#### ECM Mount Modification{7000}

Media Number -TIBU7306-00

CT660 (S/N: TRK1-UP; TKL1-UP; TJS1-UP; TGT1-UP; TSW1-UP; TSY1-UP)

Illustration 1

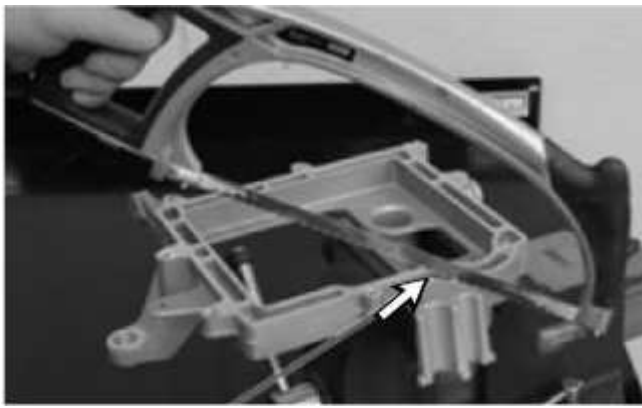
The engine harness can rub on the harness mounting location of the ECM mount.

1. Using a hack-saw or other acceptable method, cut off harness support bracket from bottom of ECM bracket.
